Our Ref: P-19107

RE: WRITTEN STATEMENT TO SUPPORT AN S4.55(1A) MODIFICATION APPLICATION TO VARY PROJECT APPROVAL MP11_0093 FOR DEVELOPMENT OF THE PEMULWUY PROJECT, REDFERN

This application seeks to modify condition B21 and Statement of Commitments item no. 16 within development consent MP11_0093 MOD1. Further detail in relation to the extent of the modifications is provided in **Section 2.2**.

Basement Level B1

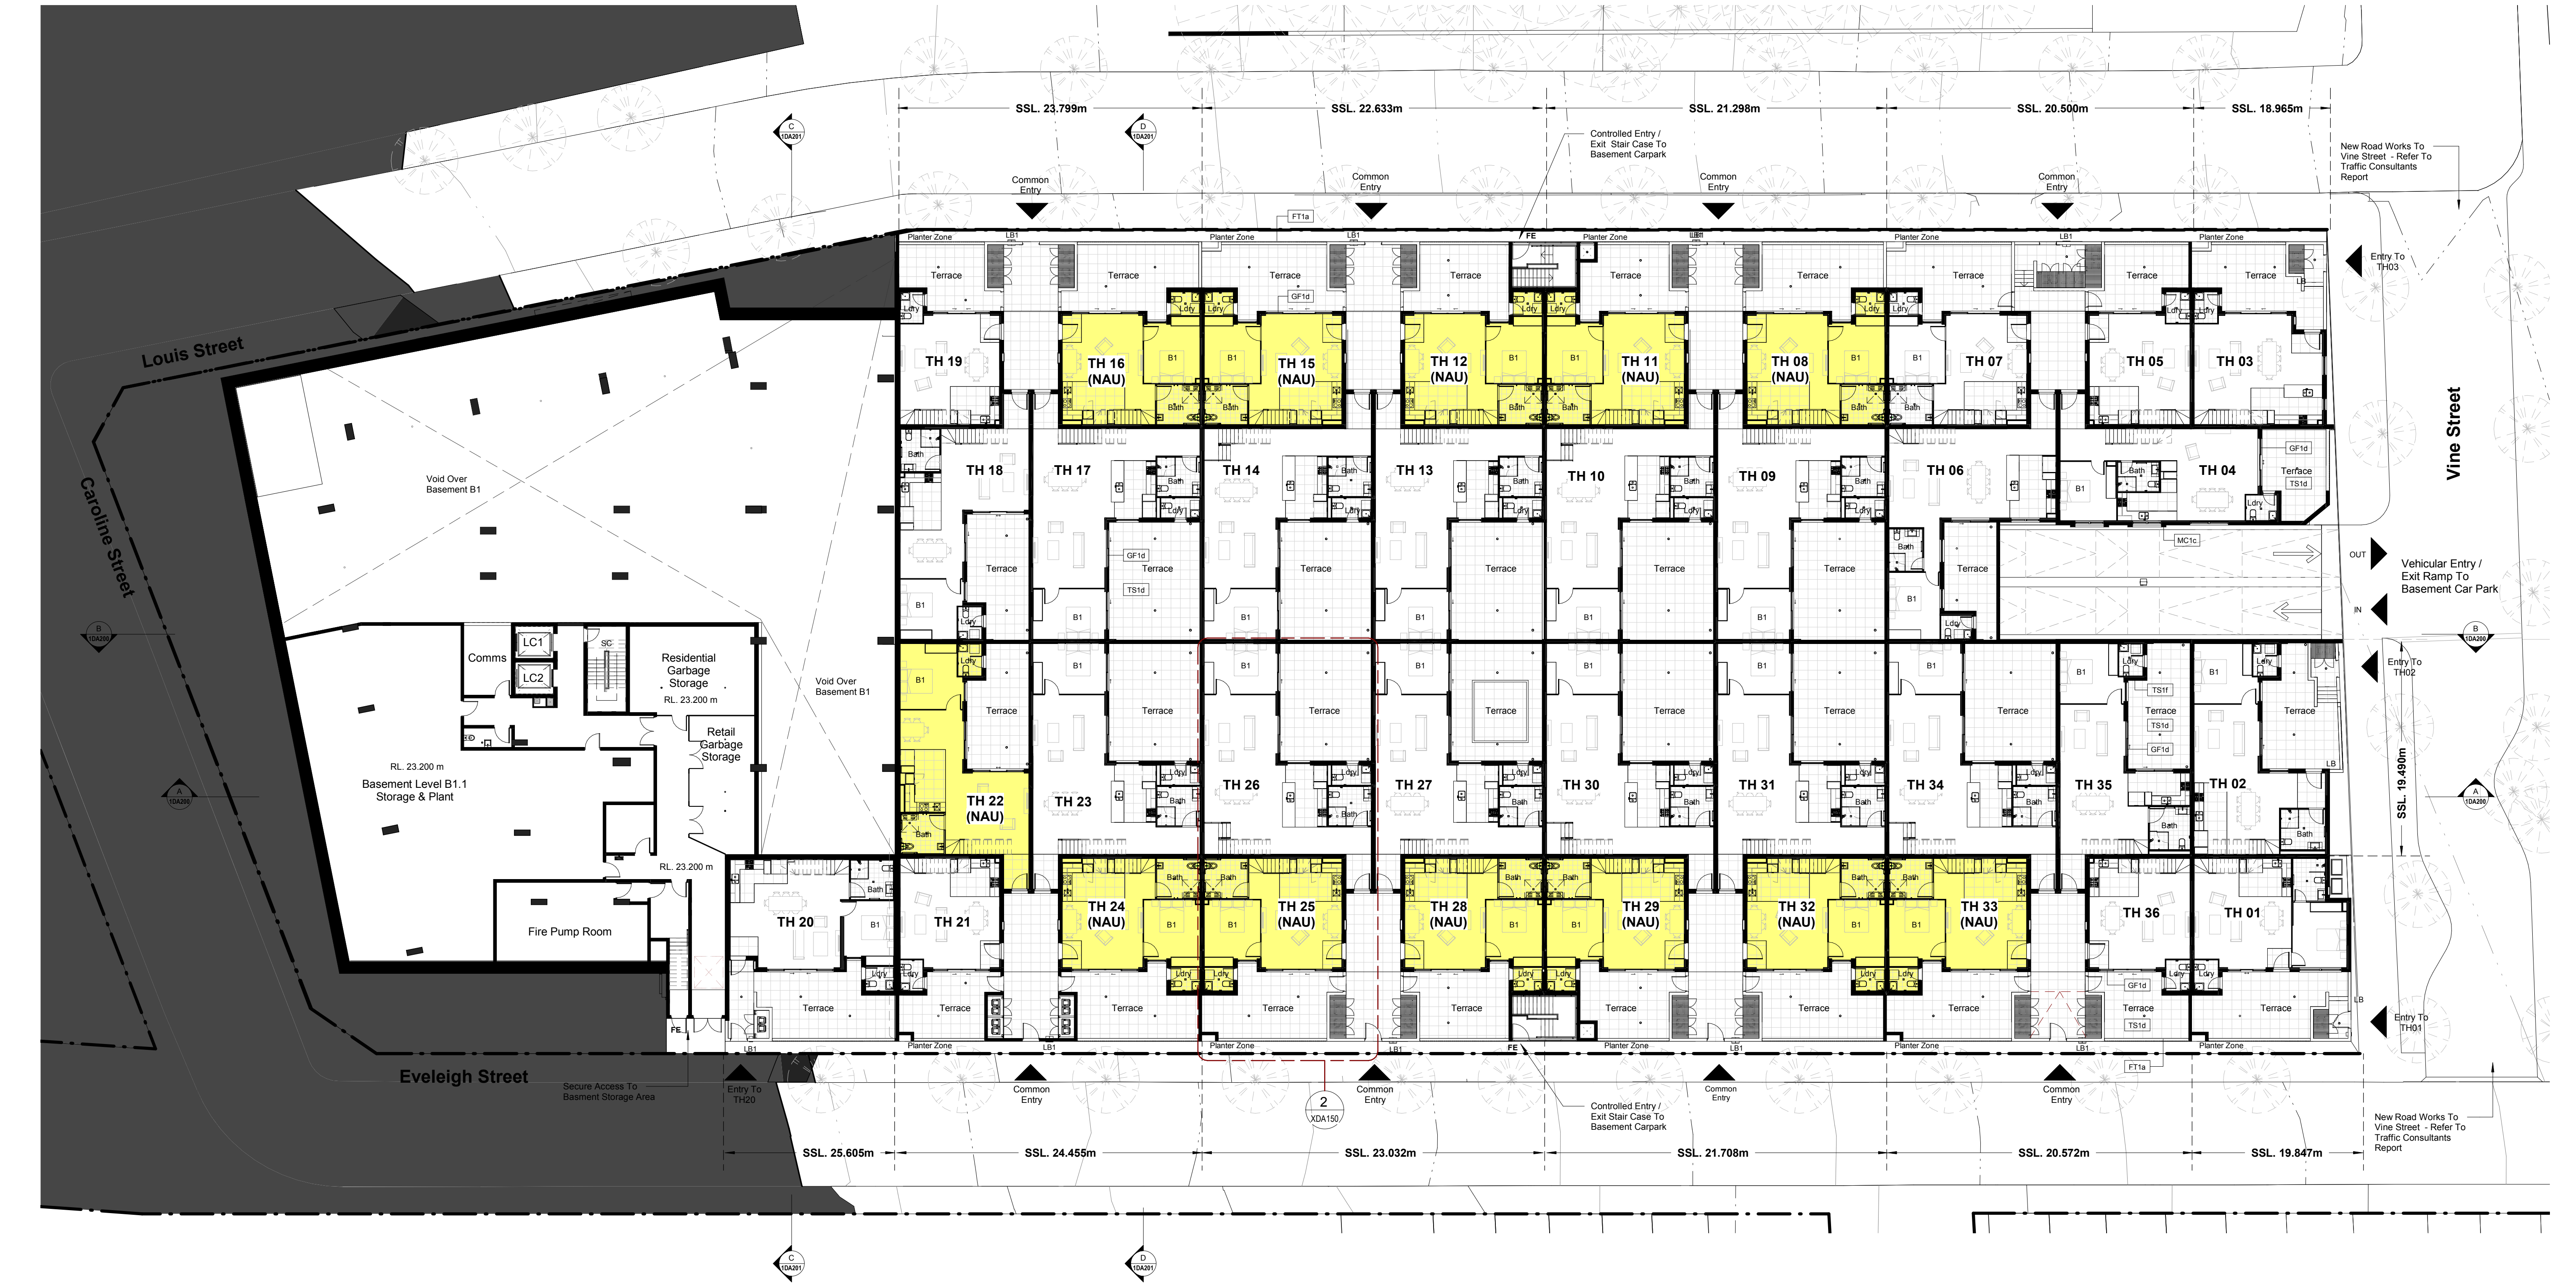
Updated architectural plans, prepared by Nordon Jago Architects, are included at **Appendix 2** and demonstrate that 16 accessible car spaces can also be accommodated within the basement car park without displacing the other required car spaces. The plans have been reviewed by a Traffic Consultant and have been certified as being compliant with the Australian Standards AS/NZS 2890.1 and AS/NZS 2890.6. A Statement of Compliance is included at **Appendix 3**.

NAU Parking Spaces (16):
8, 9, 12, 13, 14, 15, 16, 17, 18, 19, 20, 21, 22, 23, 24 & 25

E:\00_Local Files\DEI00210 Pemulwuy\DEI00210_1CD Precinct 1_RG Local_190711 (2018).rvt		JOB No.	DEI00210
TITLE	<div>Plan Level 02 - Townhouses</div> <div>Plan Level 01(GF) - Mixed Use Building</div>	DATE	Mar 2019
		SCALE	A1 @ As indicated
		DWG No.	1DA101 H

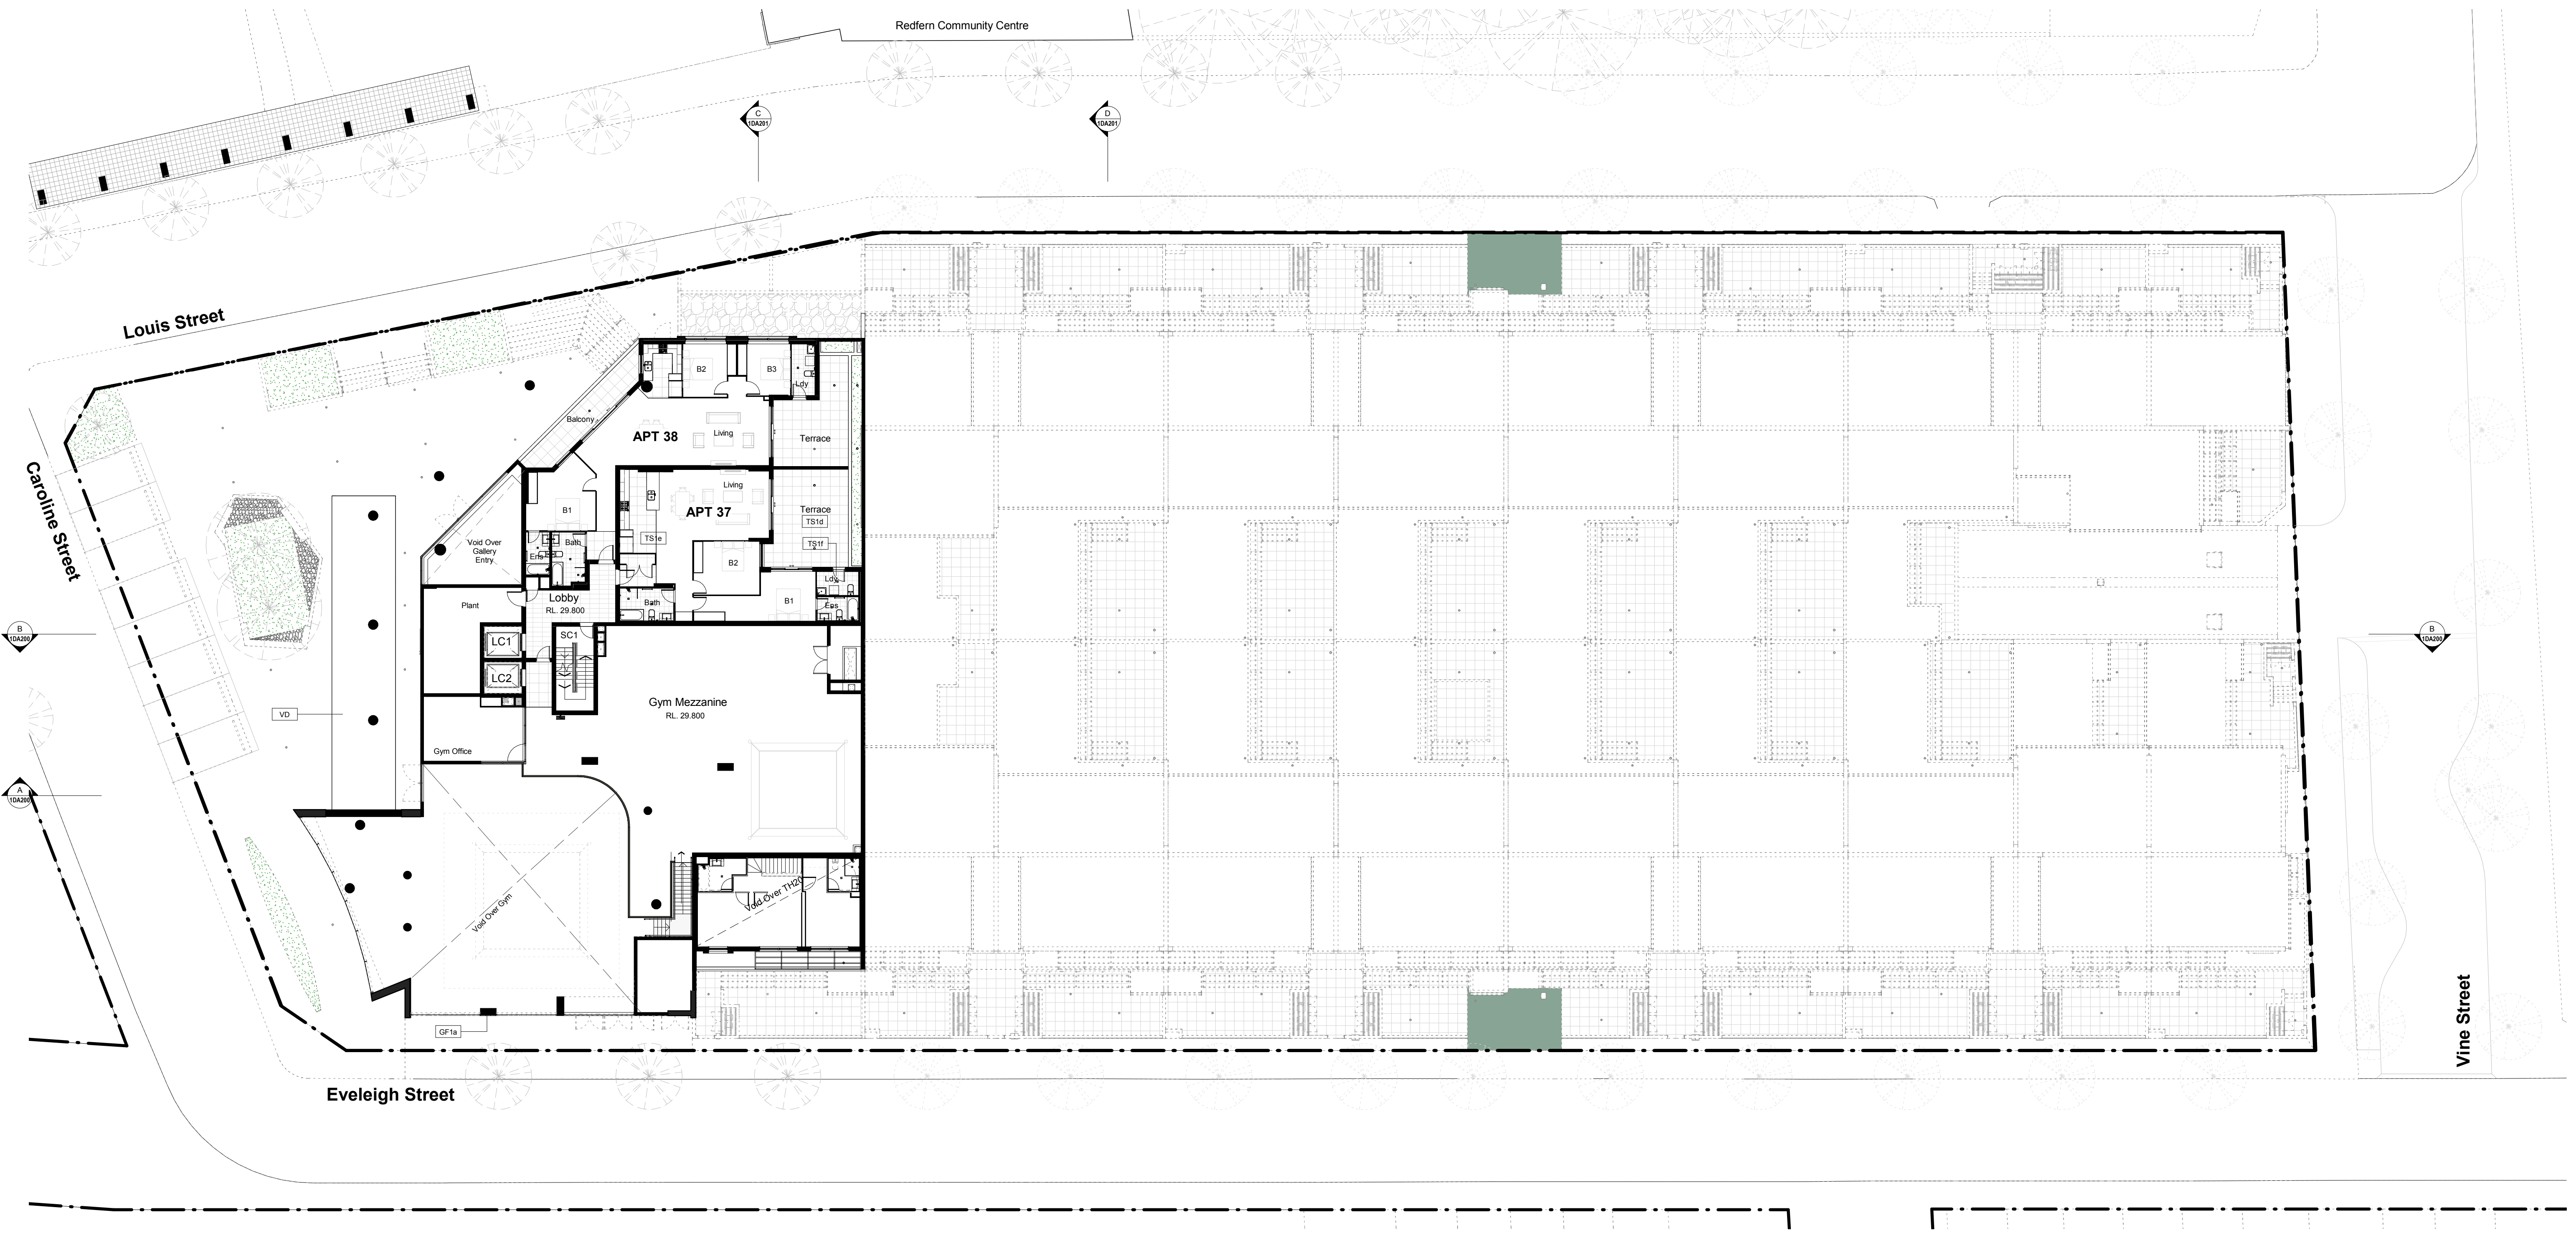
Adaptable Apartments (4):
Apartment 44 (Level 2), Apartment 50 (Level 3),
Apartment 56 (Level 4), Apartment 62 (Level 5)
